**AGENDA
TECHNICAL REVIEW COMMITTEE (TRC)
May 6, 2025
10:00AM**

**MINUTES
TECHNICAL REVIEW COMMITTEE (TRC)
April 1, 2025
10:00AM**

**RE: SWC-23 AMERICAN AUTO RV & BOAT STORAGE (AVO 043866.157)
MAJOR SITE PLAN REVIEW #2**

**RE: GRIFFIN PRESERVE PRELIMINARY PLAT (AVO 043866.154)
REVIEW #2**

PRELIMINARY DEVELOPMENT PLAN
VITA SERENA (1" = 50")

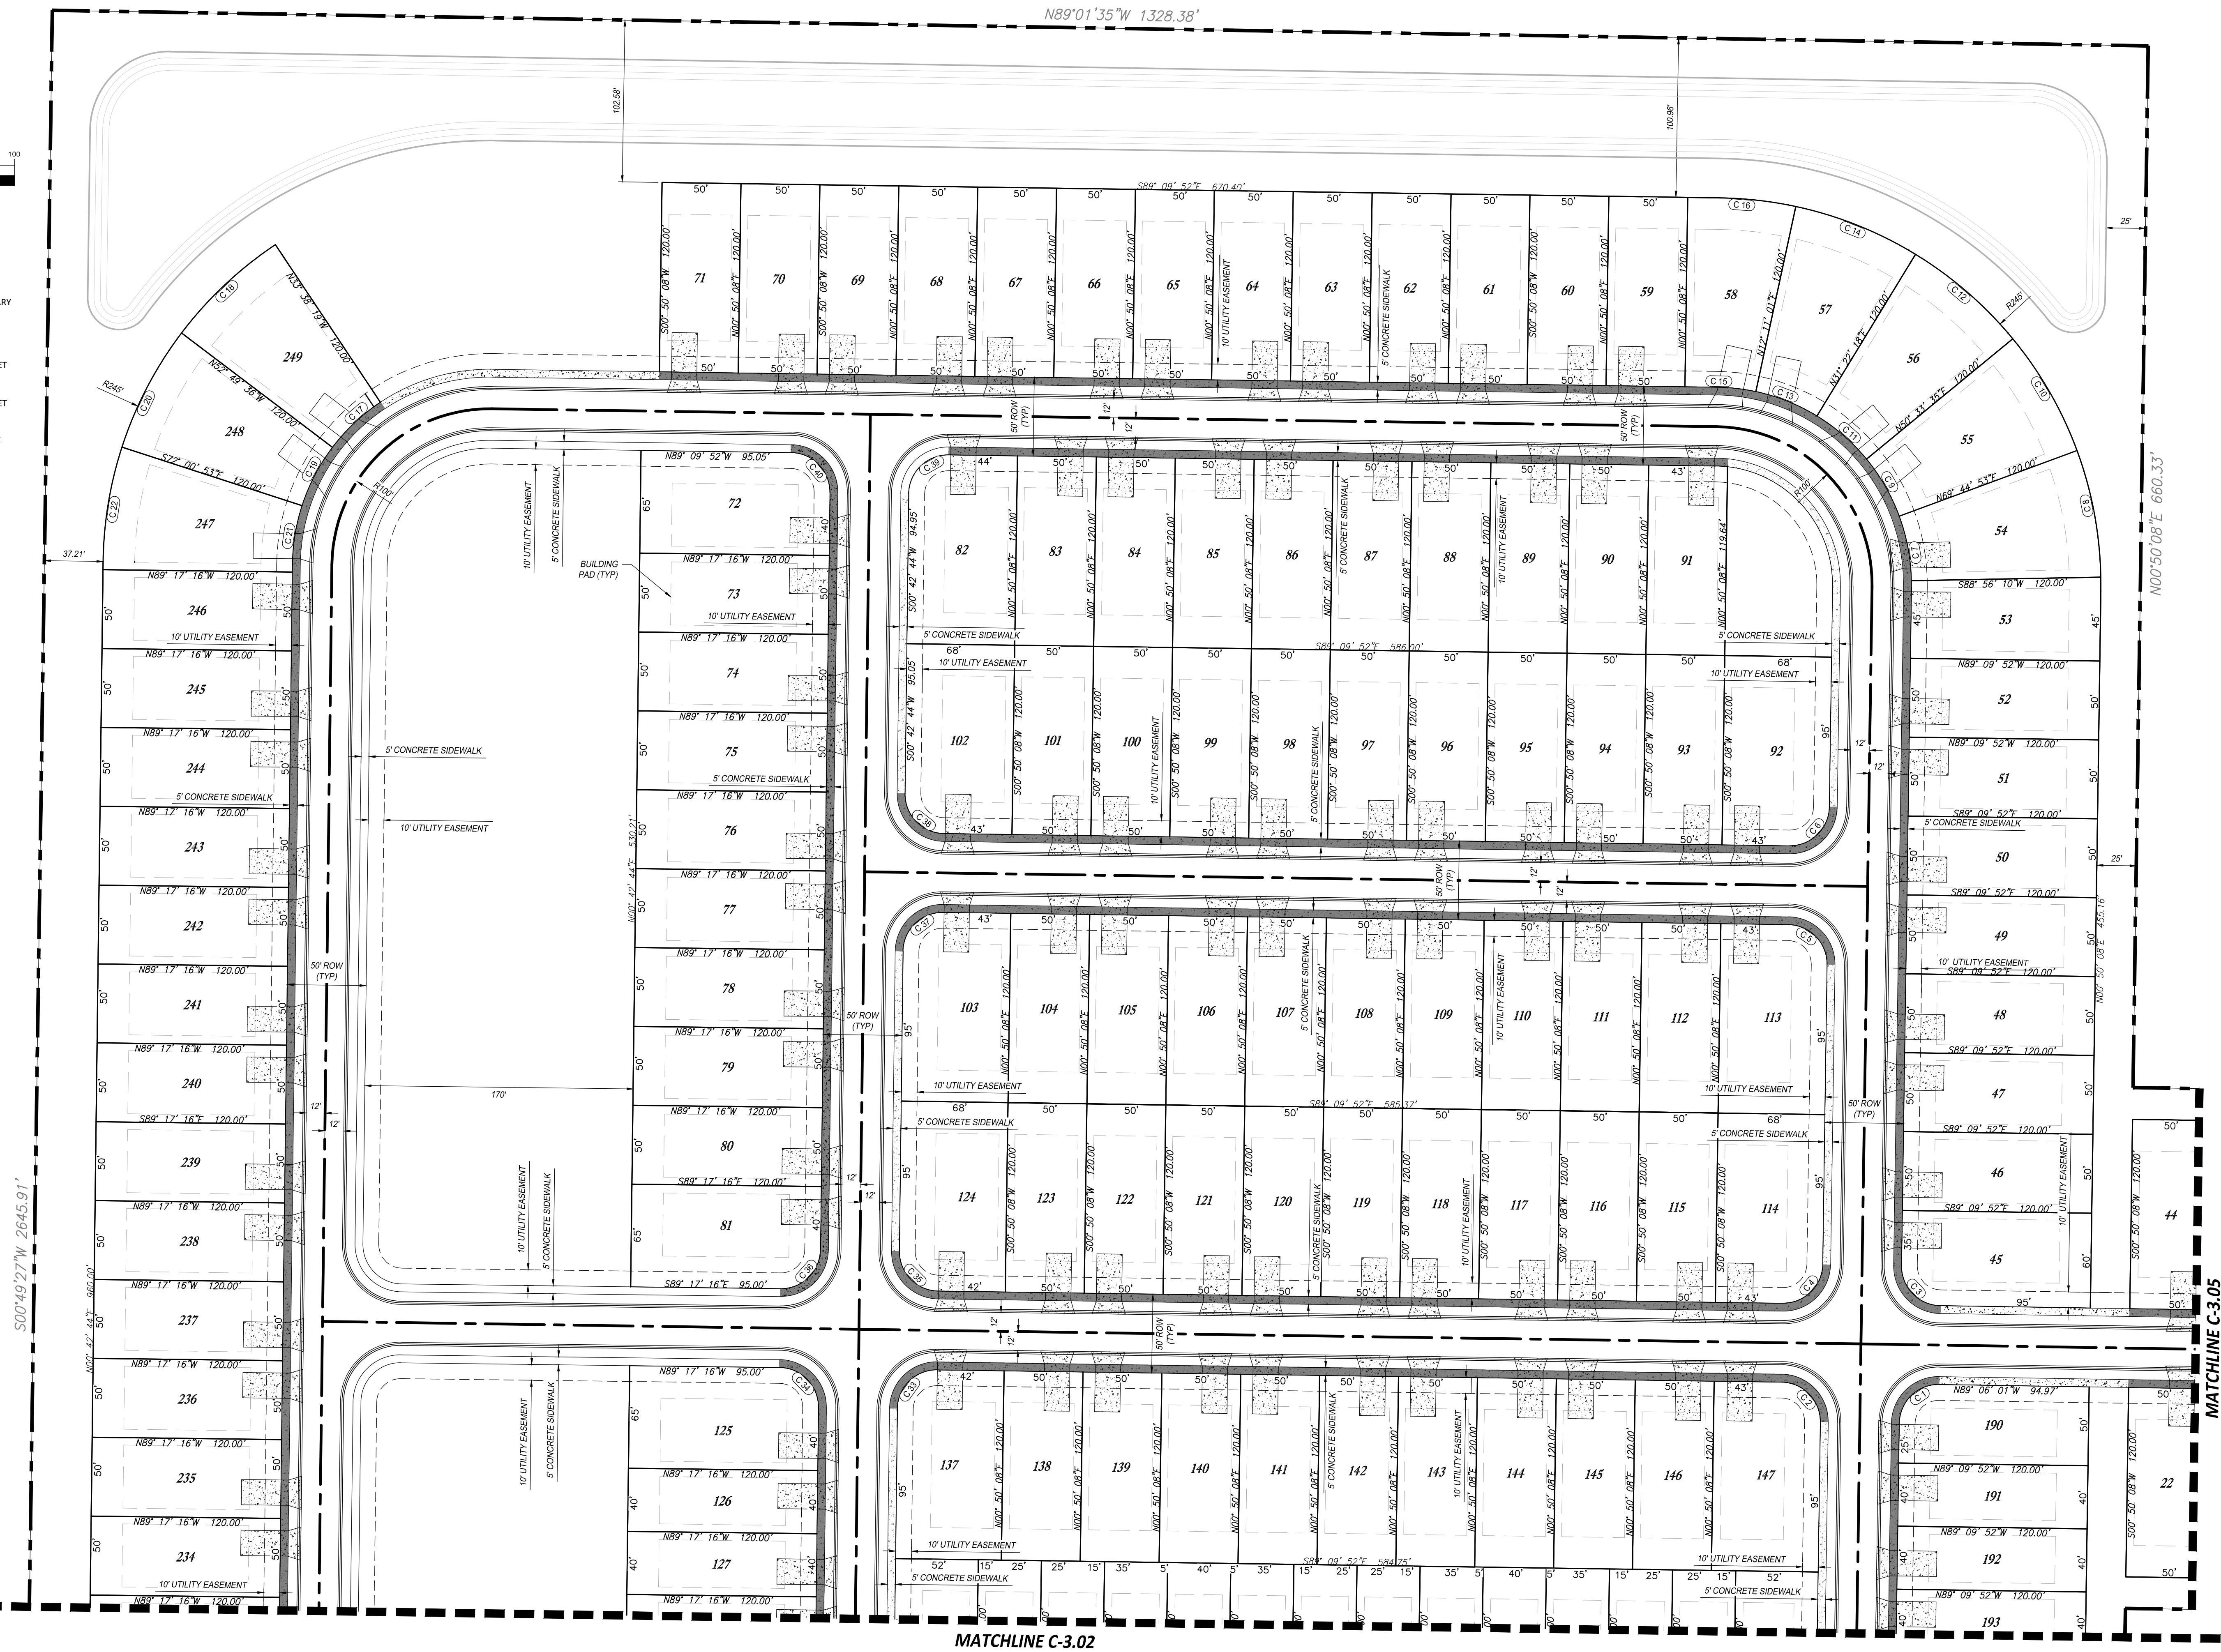
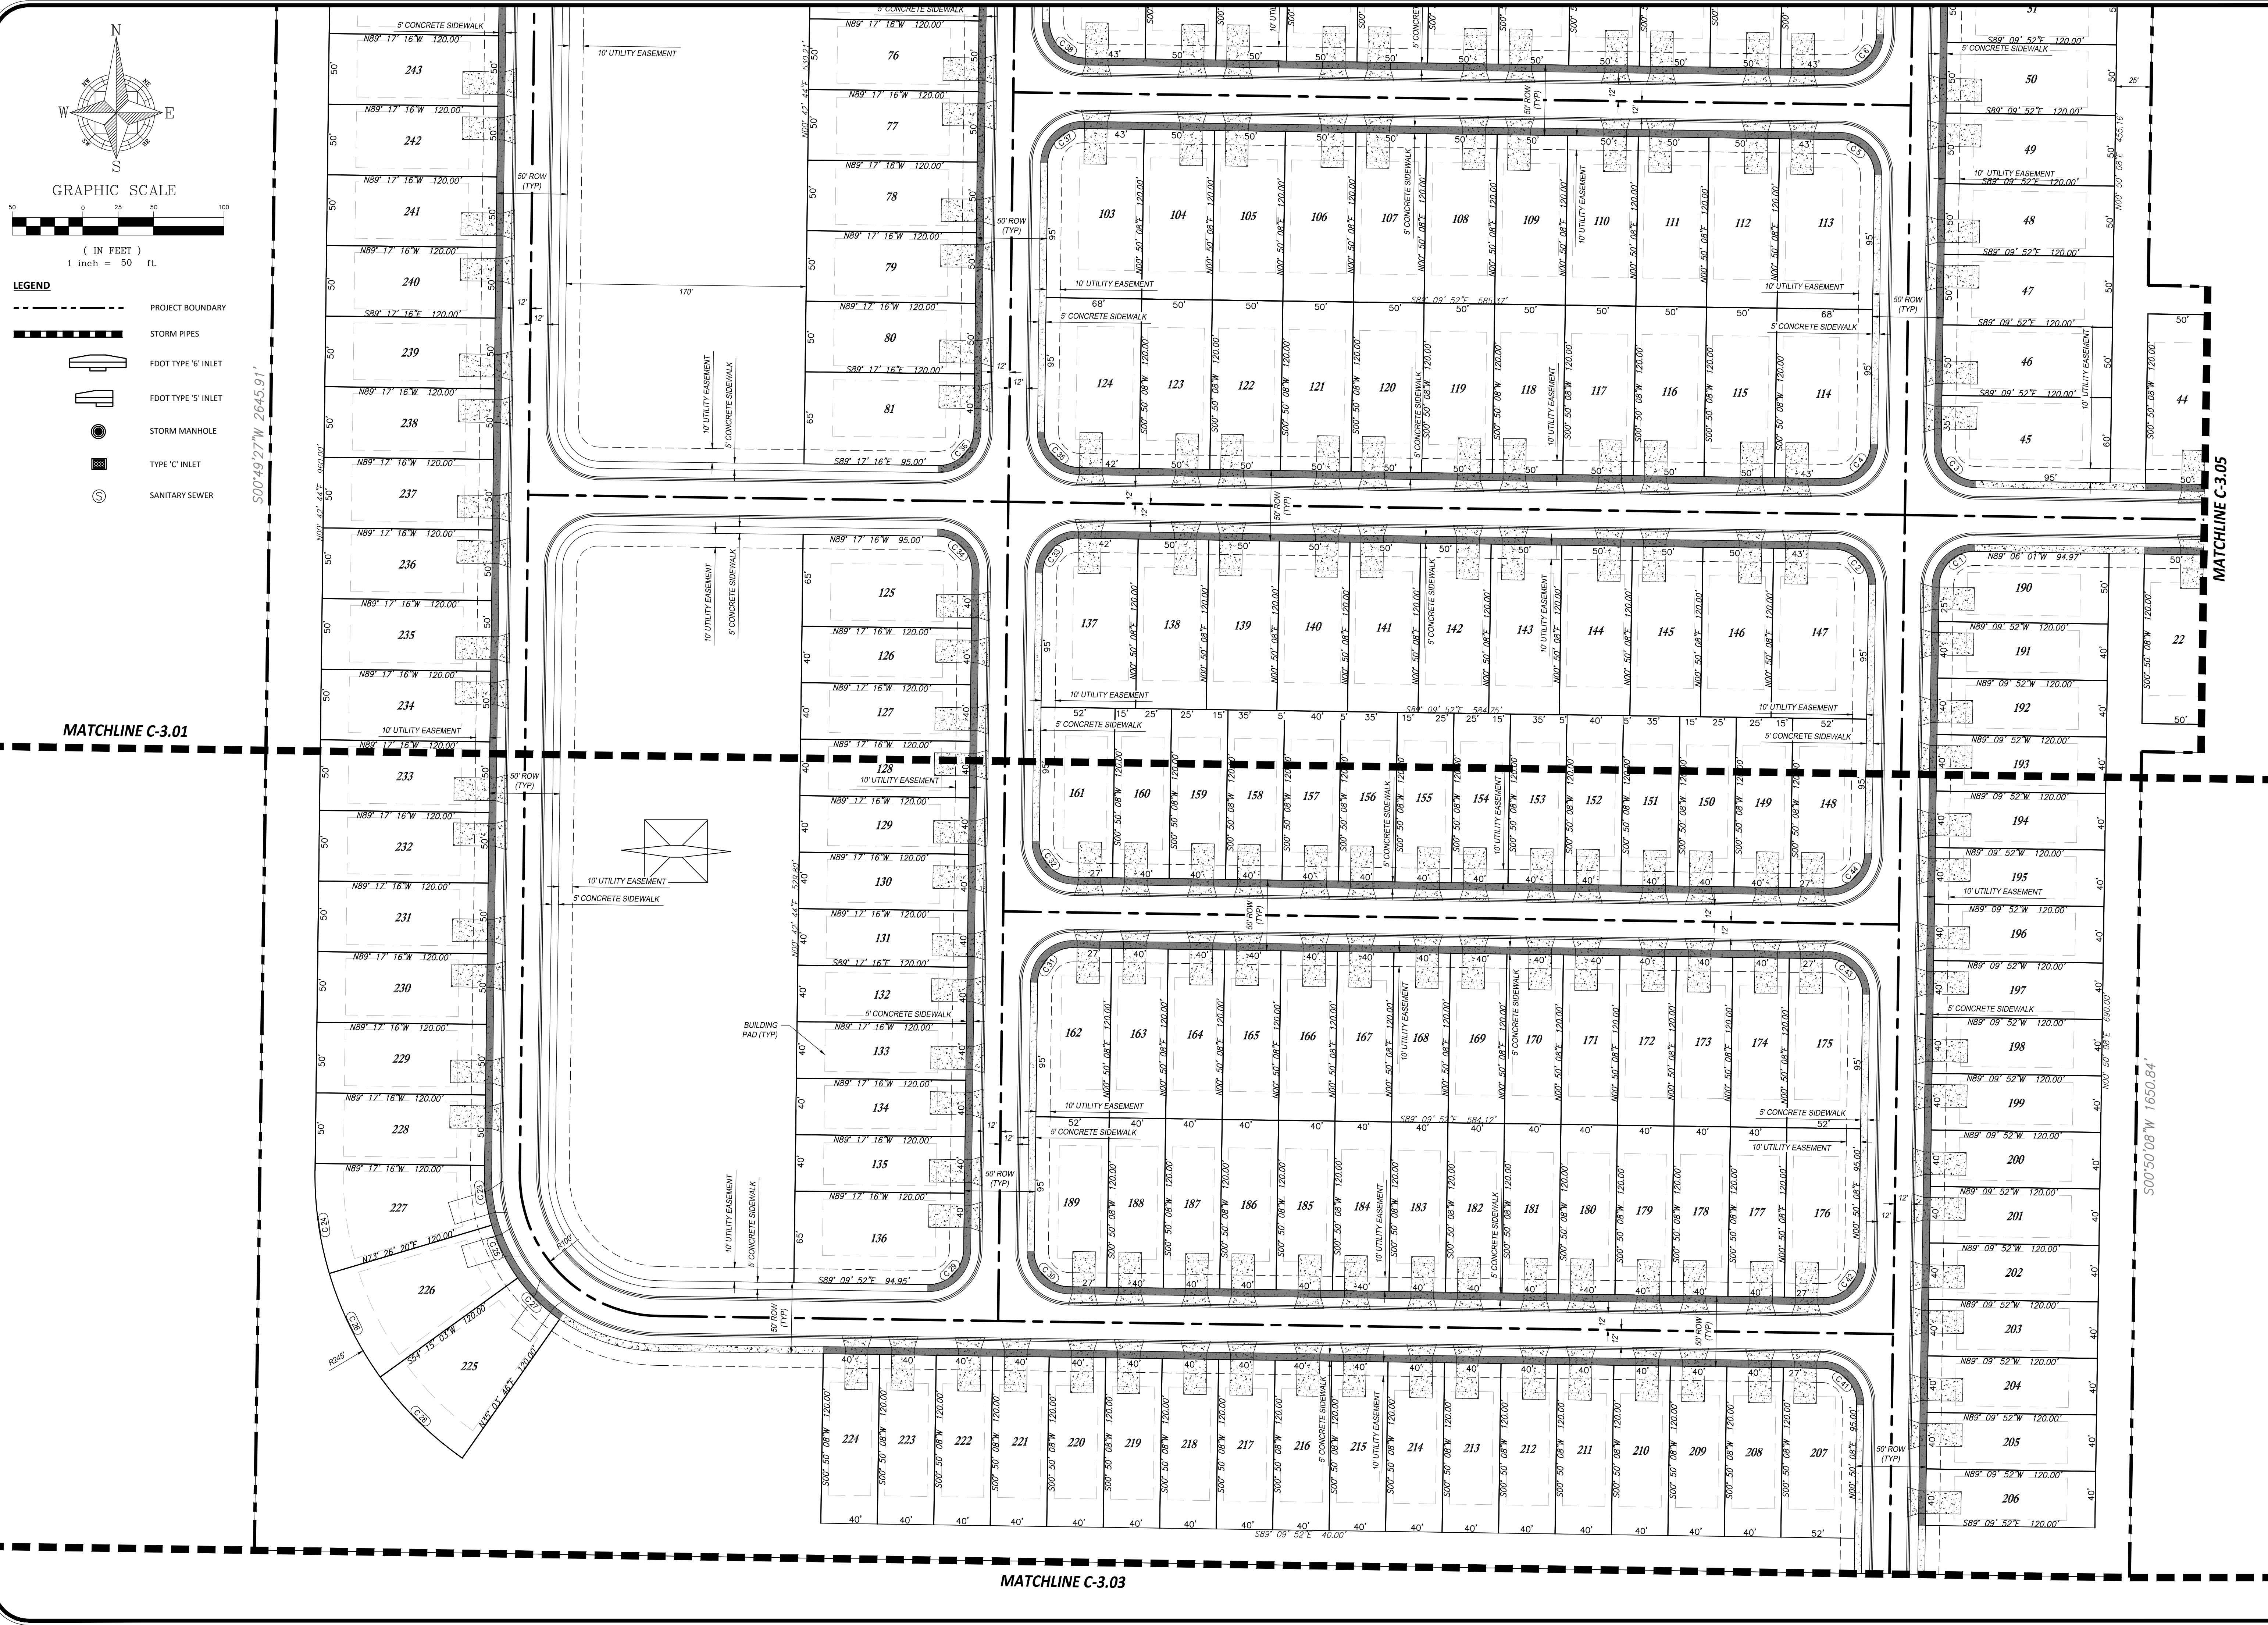
The preliminary plan does not meet the minimum requirements of Chapter 154, Section 154.030,11,G,ii. The plan is lacking the following: acreage of lots, drainage areas, common areas, and other uses; total number of lots; and typical buffer type and plantings.

The proposed development consists of 387 units, which appear to be 89 single family (SF) units on 40' x 120' lots (4,800 SF), 160 SF units on 50' x 120' lots (6,000 SF), and 138 villa (duplex) units on 35' x 120' lots (4,200 SF). Chapter 154 indicates that the residential districts maximum building coverage is 30% which the proposed lots appear to exceed. A waiver to the maximum building coverage may be required. The plans indicate townhome units; however, this area appears to indicate the villa units (duplex). The applicant may want to review Chapter 151, Definitions and see review the definitions under dwelling. The conceptual plan checklist submitted indicates minimum lot sizes of 40' x 115' and 50' x 115'; however, the plans indicate 40' x 120' and 50' x 120'. Please clarify.

The survey indicates an existing 170' wide utility easement granted to Florida Power near the western boundary. The plans indicate road crossings and parks within the easement. Please verify that these encroachments are allowable. Chapter 154, Section 154.030(H) identify open space requirements of 25% of the total project area shall be established for common open space. Further, common open space set aside for recreational use shall be suitable improved. Based on the size of the development, it is highly recommended that at least 4 amenities be provided. Amenities such as parks with playgrounds, picnic/barbeque areas, community building, multi-modal paths, basketball courts, etc. Please revise plans to clearly indicate proposal common open space and recreational use areas with amenities.

Chapter 164, Section 164.030(b) indicates that the buffers within a PUD are to be reviewed individually with each application. The plan does indicate that they are providing a 25' perimeter buffer; however, it does not indicate the type of buffer or a cross section of the proposed buffer plantings. Chapter 164, Section 164.030(b) identifies that a 25' buffer is a Type "C" consisting of 5 canopy trees, 4 understory trees, and 30 shrubs per 100'. Please revise the

plans to clearly indicate the buffer type proposed. Please also be advised that stormwater ponds are not allowed within the buffers (Chapter 164, Section 164.030(c)).

1. Preliminary Site Plan uses several line types, hatches, etc. that are not defined in the legend. Update legend so it is clear what the plan is communicating.

2. Appears to be a proposed development shown on PID 06-19-24-0003-000-01900, clarify what this development is and if it's part of the application.
3. Coordinate with the County if accessible driveway connection spacing is provided on CR 466A.

4. Driveway stub provided to PID 06-19-24-0003-000-01900 does not line up with shown development.
5. Preliminary Site Plan shall include perimeter buffers and setbacks from perimeter boundary. Clearly label and dimension the minimum perimeter buffers and setbacks being proposed. (154.030, d, 11, G, i, e)

6. Clarify where the Internal Lot Line of 0 feet is being used on the Preliminary Site Plan.
7. Indicate the total number of units and their type. Preliminary Site Plan currently has "?" for many areas involving this value. (154.030, d, 11, G, i, h)

9. On the Preliminary Site Plan, clearly indicate which lots are Single Family and which are Multi Family in the plan view, plan summary table, and typical details.

10. On the Preliminary Site Plan, indicate what the zoning is of the properties adjacent to the development (154.030, d, 11, G, i, j)
11. On the Preliminary Site Plan, indicate what the anticipated phasing plan is. (154.030, d, 11, G, i, l)

12. On the Preliminary Site Plan, indicate what the percentage of the Open Space is and its location. (154.030, d, 11, G, i, n)
13. On the Preliminary Site Plan, indicate the acreage of Parks/Recreation is and its location. (154.030, d, 11, G, i, n)

14. On the Preliminary Site Plan, provide the soils area and 100-year flood prone areas. There appears to be a closed depression located on Parcel 1 which could be flood prone (154.030, d, 11, G, i, q)

15. On the Preliminary Site Plan, provide net living area for each type of dwelling. Two living areas are provided, however, there are 3 types of dwellings. (154.030, d, 11, G, i, t)

20. On the Preliminary Site Plan, provide the proposed stormwater management plan and drainage control facilities. Very difficult to see on first plan sheet. (154.030, d, 11, G, ii, j)

Please revise the preliminary plan as outlined above. Please submit additional data as outlined above.
